Project Name	30 Fairlight St, Fairlight	Project Number	00012781
Project Address	30 Fairlight St, Fairlight, NSW 2094	Drawing Name	Basement Plan
		Scale	1:150, 1:1 (A3)
		Date	August 2023
Client	Adjani Pty Ltd	Drawing Number	DA200
		Revision	I

**MOD2023/0479**

**SCHEDULE OF CHANGES**

PROJECT  
Residential Development  
30 Fairlight street,  
FAIRLIGHT, NSW

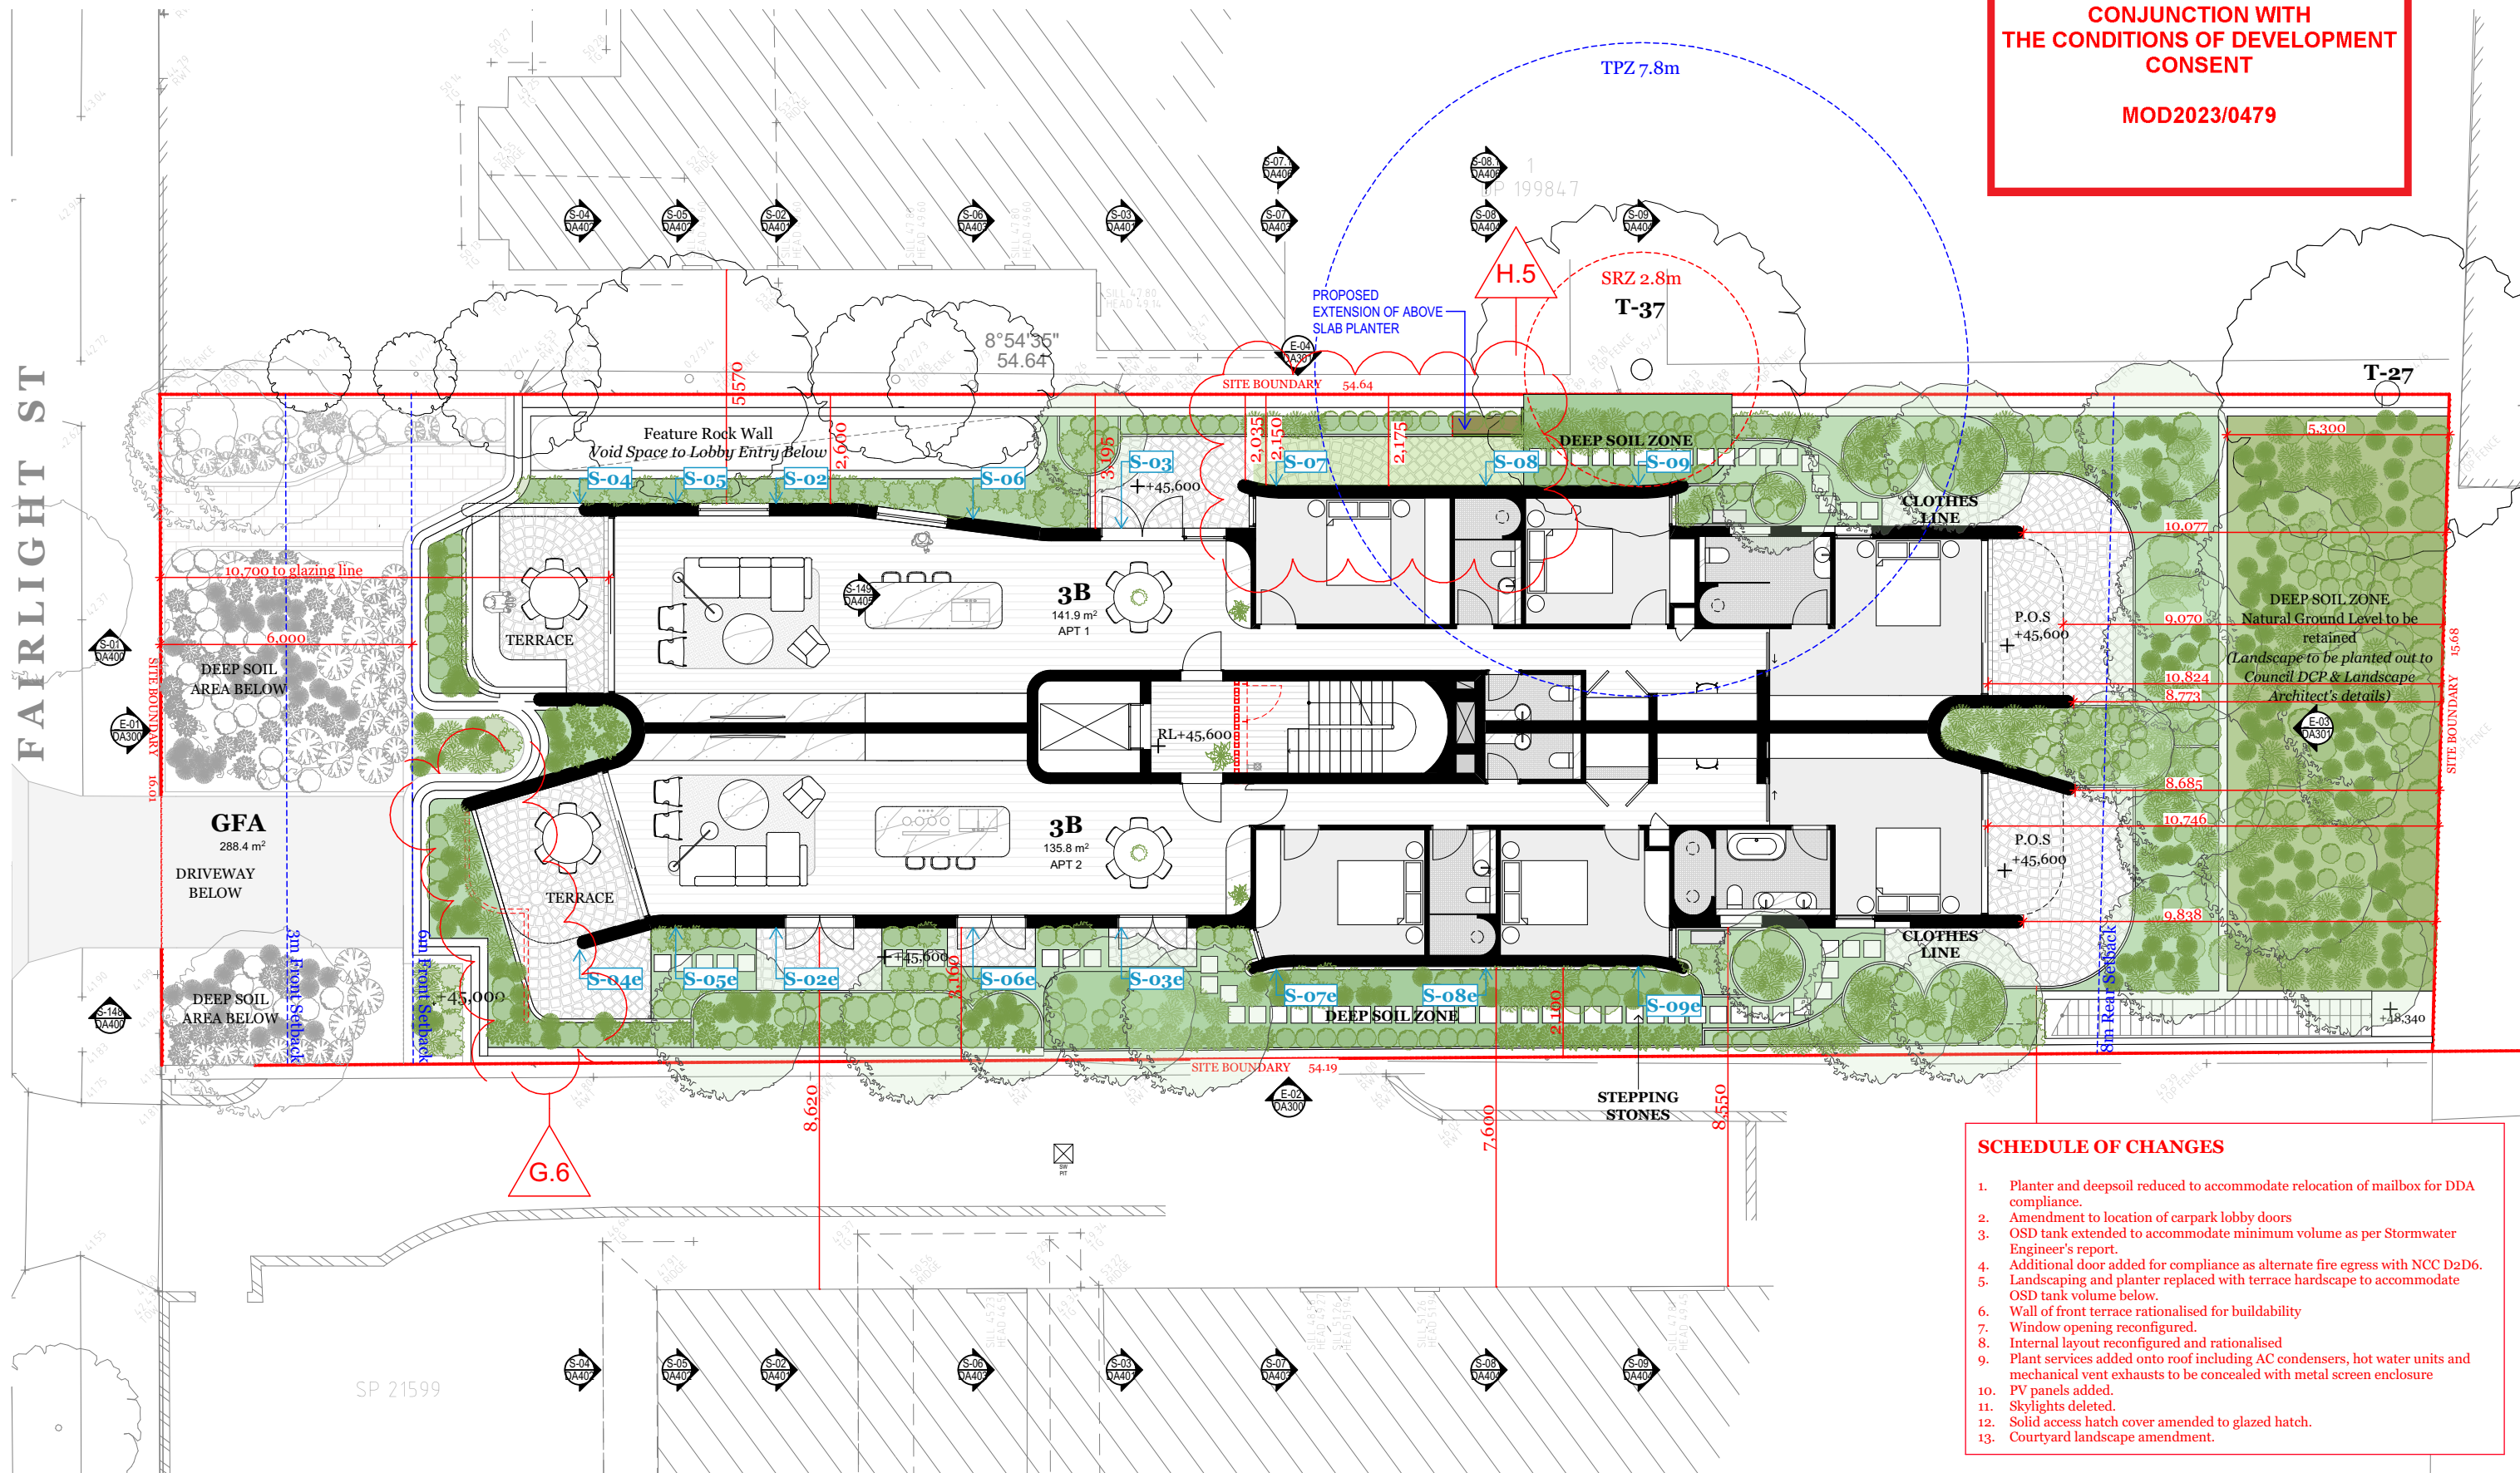
1. Planter and deepsoil reduced to accommodate relocation of mailbox for DDA compliance.
2. Amendment to location of carpark lobby doors
3. OSD tank extended to accommodate minimum volume as per Stormwater Engineer's report.
4. Additional door added for compliance as alternate fire egress with NCC D2D6.
5. Landscaping and planter replaced with terrace hardscape to accommodate OSD tank volume below.
6. Wall of front terrace rationalised for buildability
7. Window opening reconfigured.
8. Internal layout reconfigured and rationalised
9. Plant services added onto roof including AC condensers, hot water units and mechanical vent exhausts to be concealed with metal screen enclosure
10. PV panels added.
11. Skylights deleted.
12. Solid access hatch cover amended to glazed hatch.
13. Courtyard landscape amendment.

00012781  
Roof Plan  
1:150, 1:1 (A3)  
August 2023

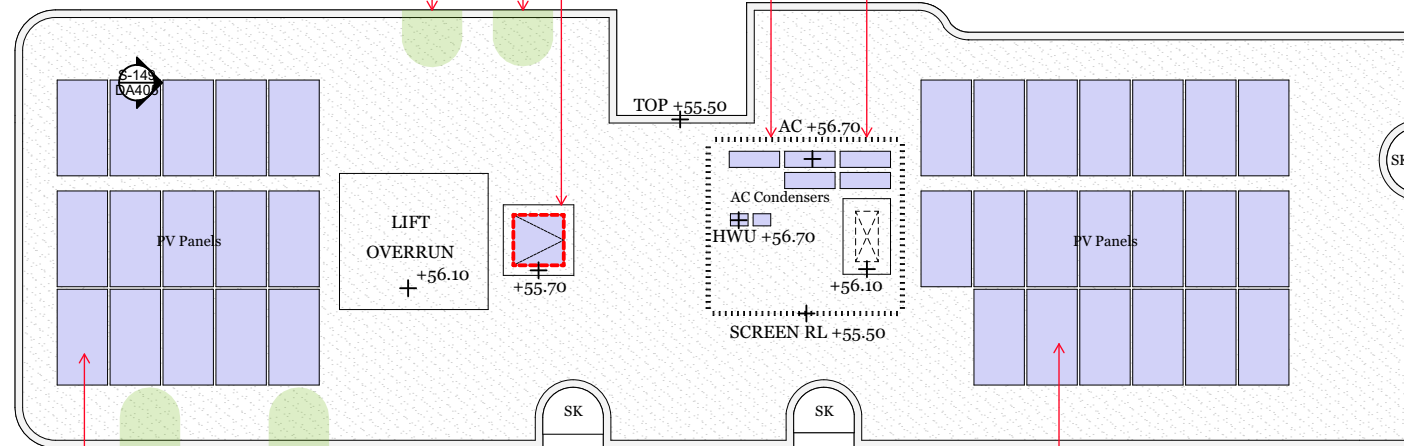
9. New proposed plant enclosure for AC condensers,  
mechanical exhaust and hot water units

12. Solid access hatch amended to glazed hatch

11. Skylights deleted

11. Skylights deleted

10. PV Panels added

Section - S-03

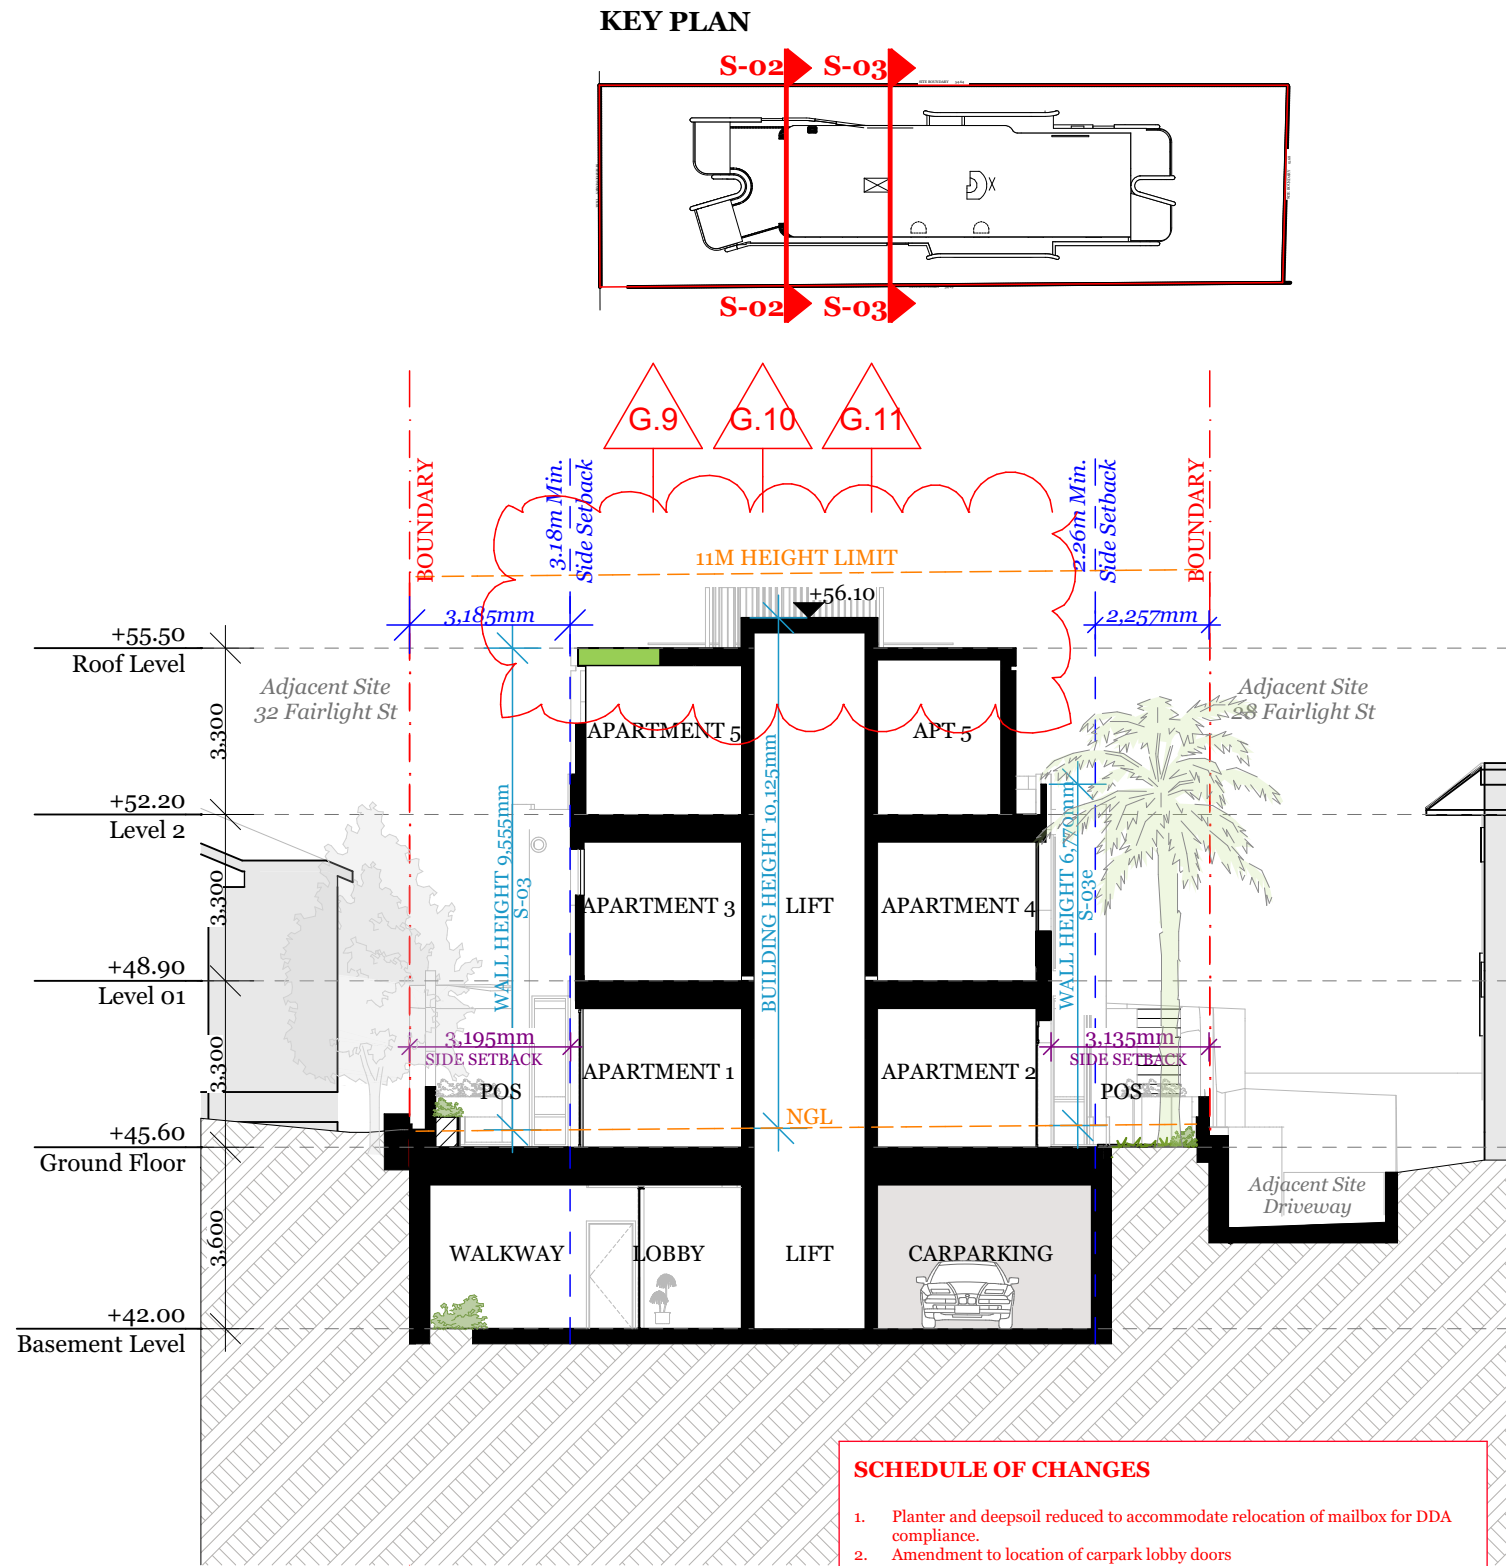
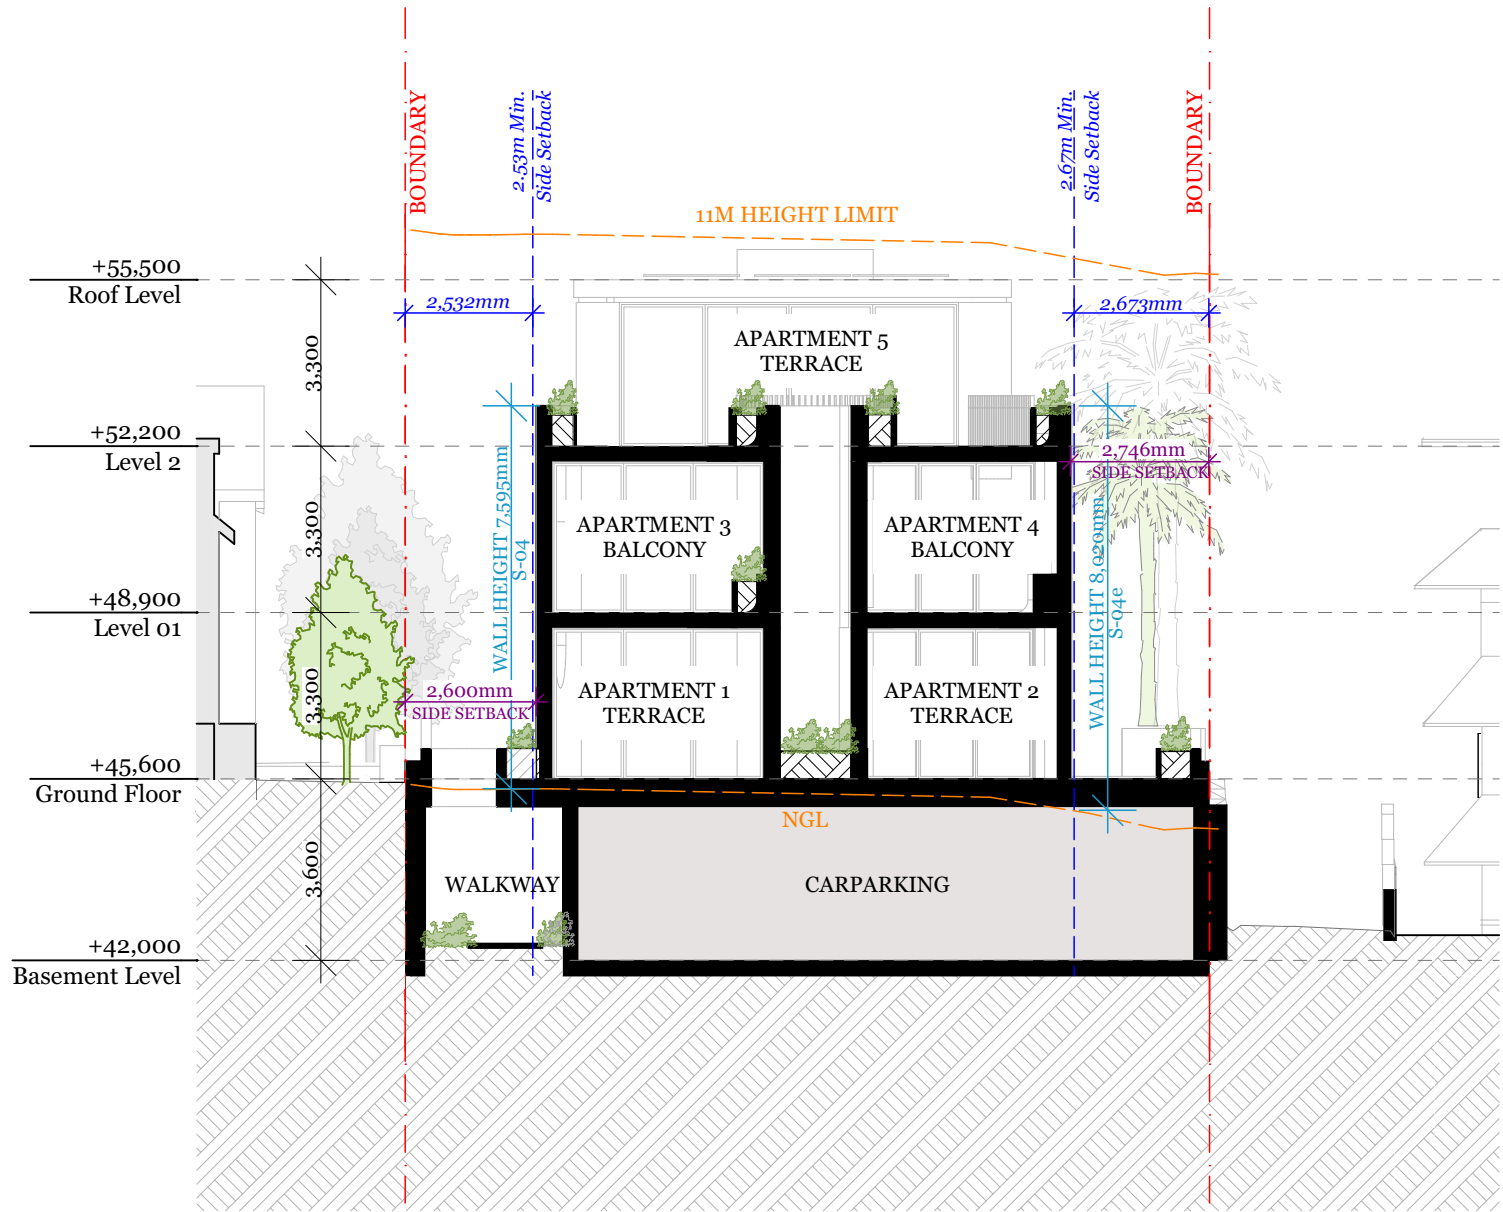
Planter and deepsoil reduced to accommodate relocation of mailbox for DDA compliance.
2.

Amendment to location of carpark lobby doors
3.

OSD tank extended to accommodate minimum volume as per Stormwater Engineer's report.
4.

Additional door added for compliance as alternate fire egress with NCC D2D6.
5.

Landscaping and planter replaced with terrace hardscape to accommodate OSD tank volume below.
6.

Wall of front terrace rationalised for buildability
7.

Window opening reconfigured.
8.

Internal layout reconfigured and rationalised
9.

Plant services added onto roof including AC condensers, hot water units and mechanical vent exhausts to be concealed with metal screen enclosure
10.

PV panels added.
11.

Skylights deleted.
12.

Solid access hatch cover amended to glazed hatch.
13.

Courtyard landscape amendment.
